APPLICATION AND
PRELIMINARY PLAT CHECKLIST

Name of Proposed Subdivision HARLAN PARK

FACT SHEET

Staff Comments: Technical comments include:

SITE PLAN

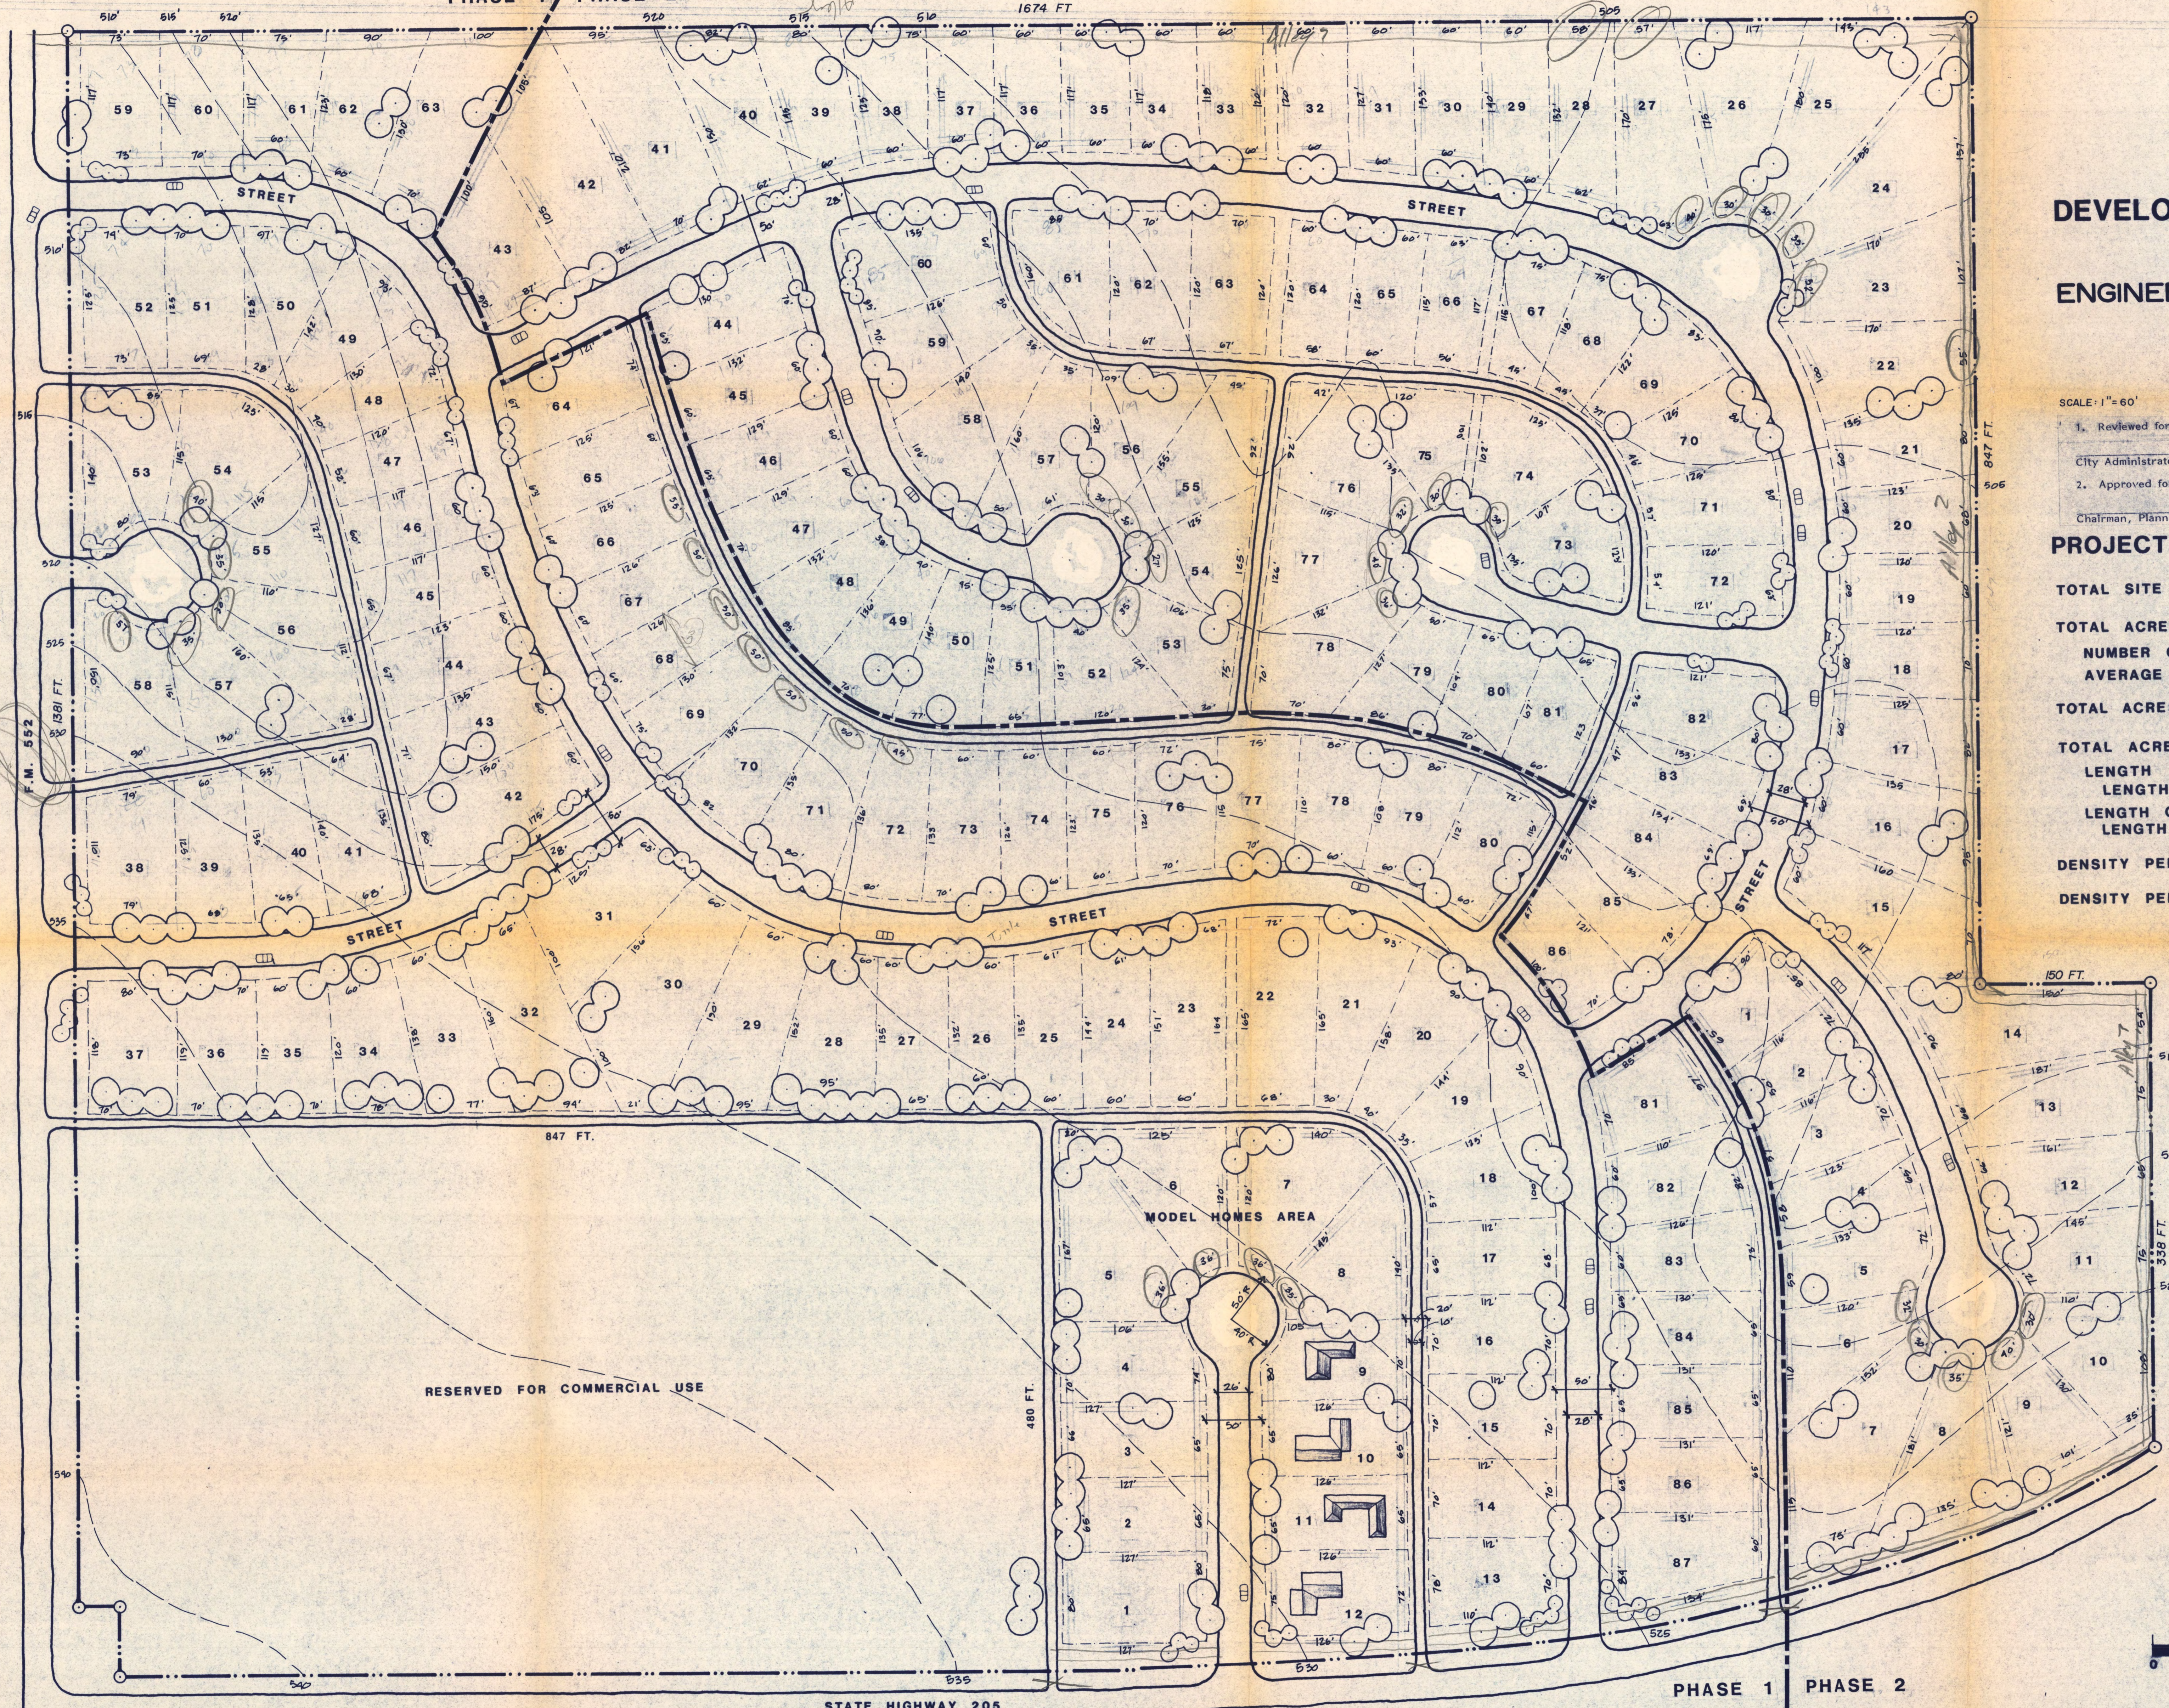
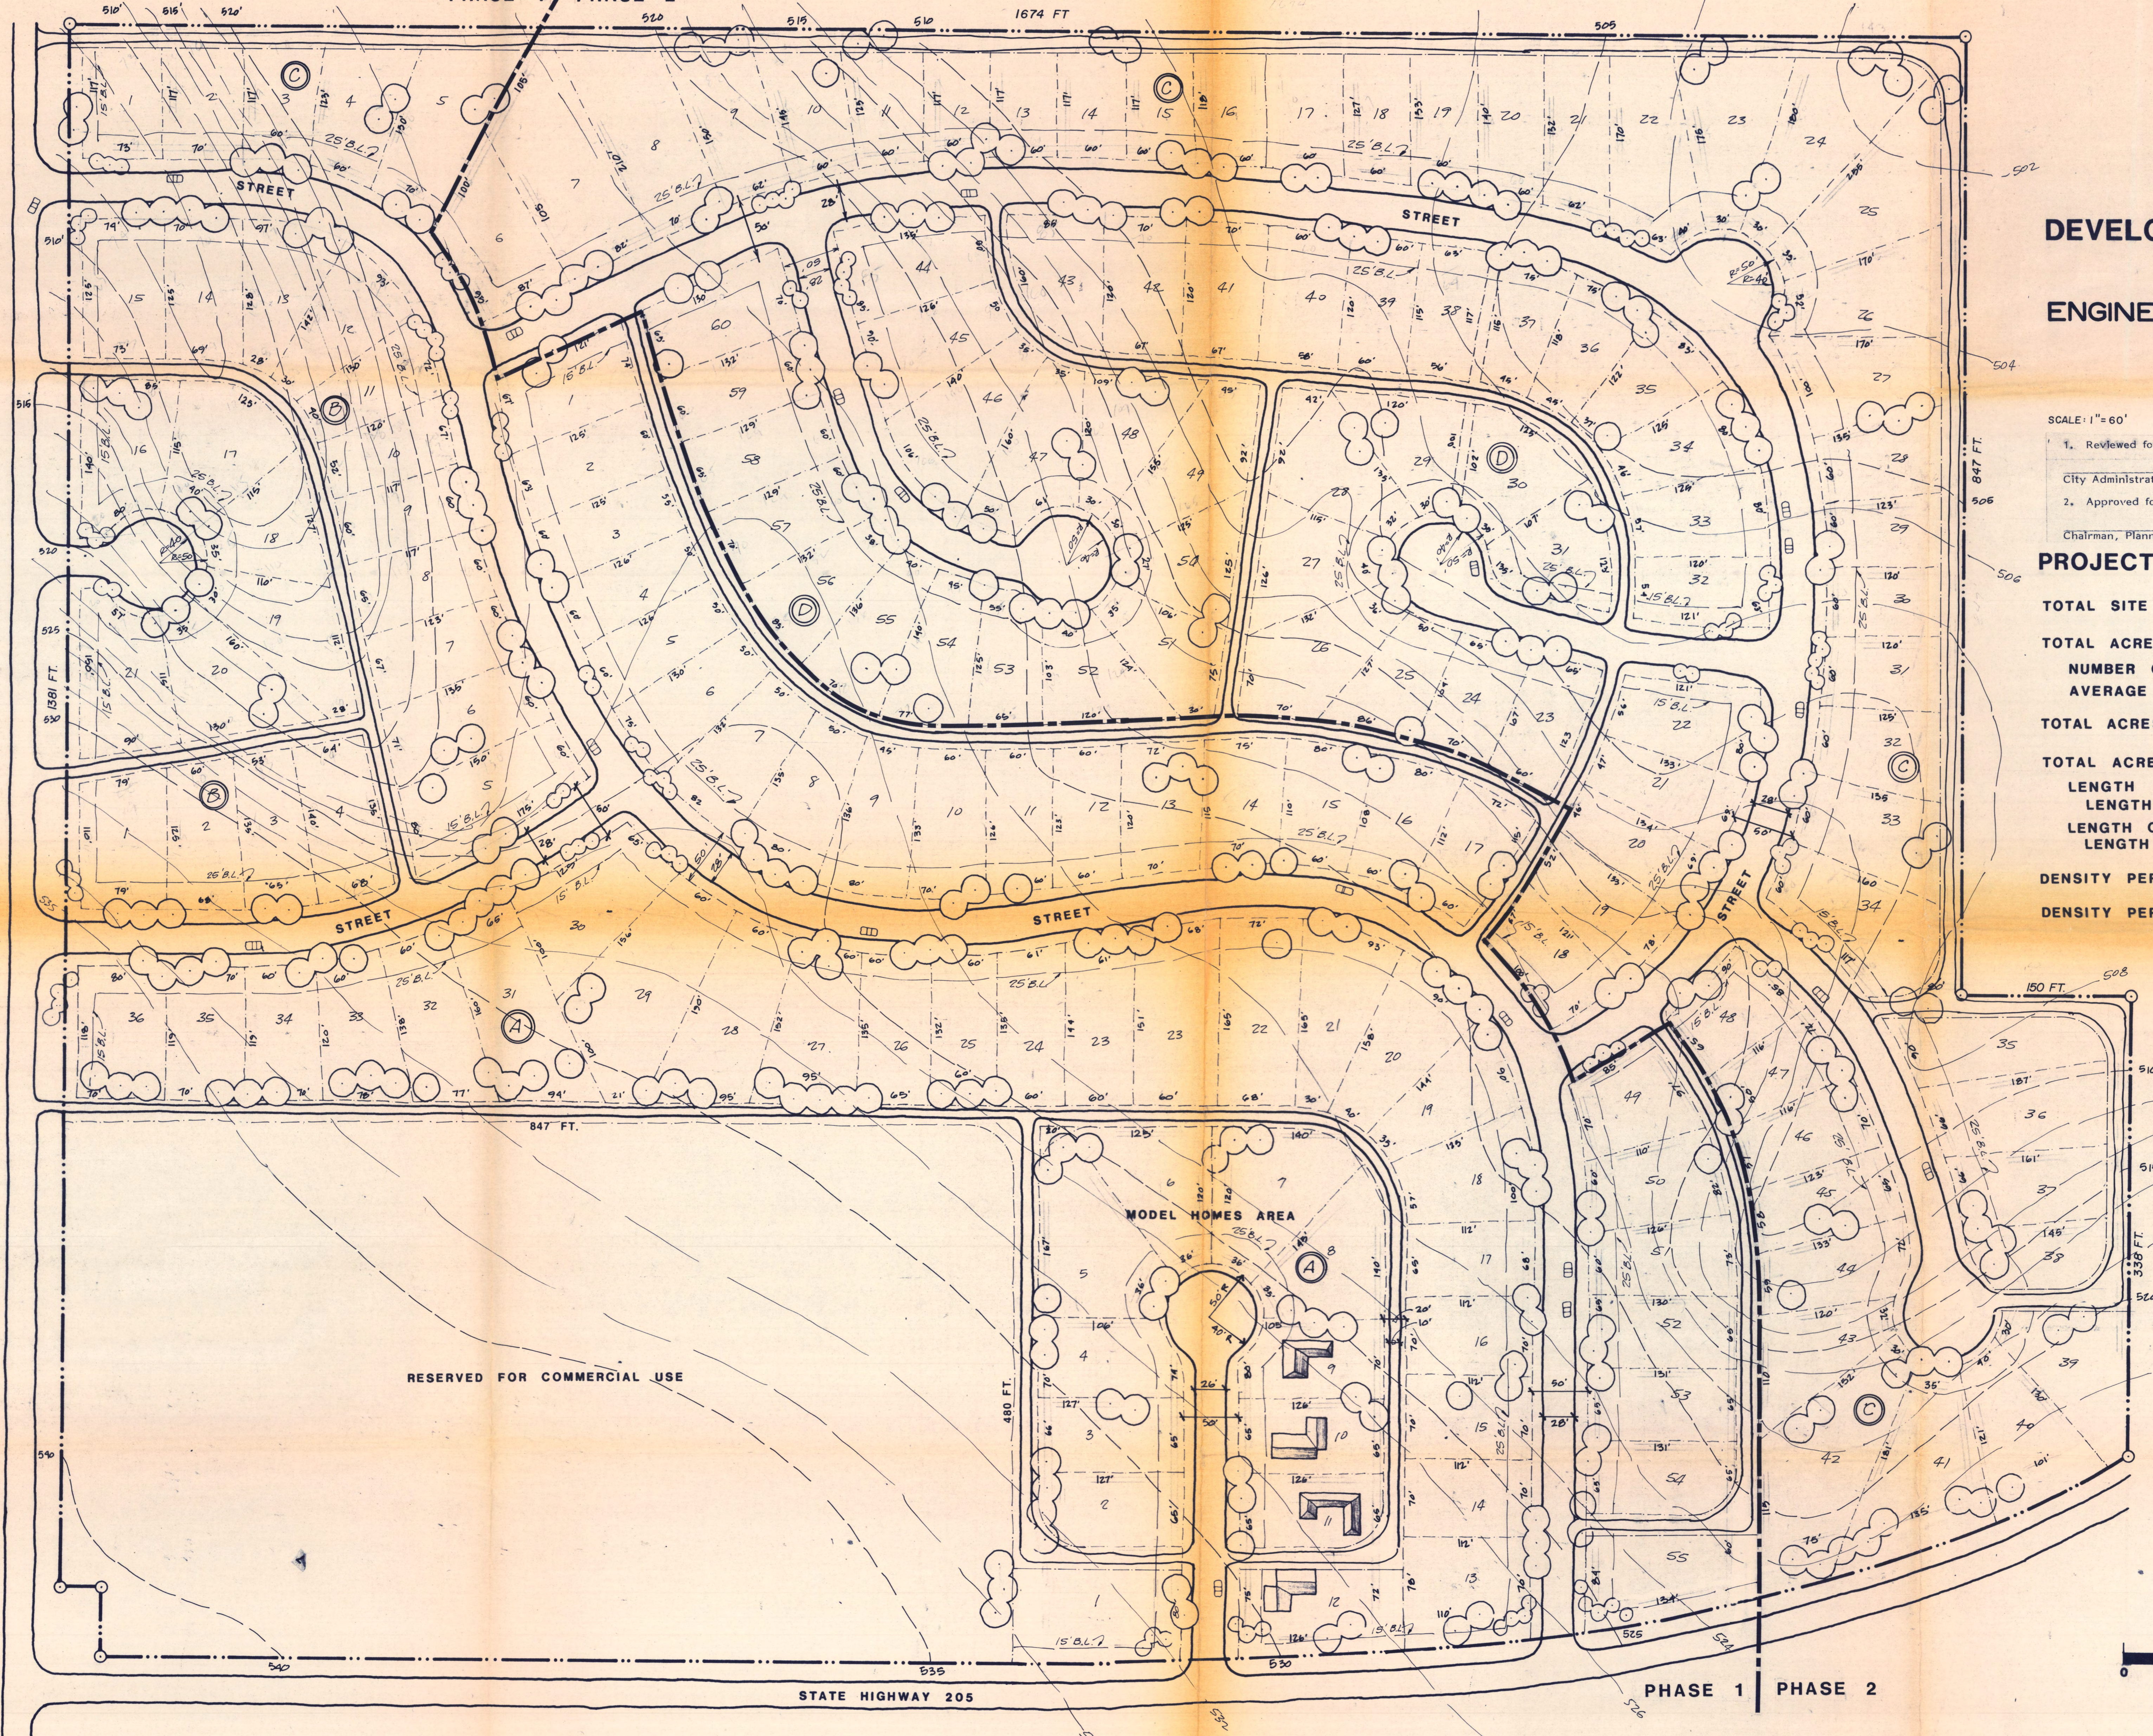
1. Need building setback lines
2. Need 2 ft. contours
3. Need legal description and dedication
4. No block letters, need to be renumbered
5. Southern boundary road not SH-552
6. Remove alley access to SH-205. Need alleys on north and west sides
7. Need ROW dimensions - 50ft
8. Cul-de-sac lots frontages not large enough; some rear widths too small
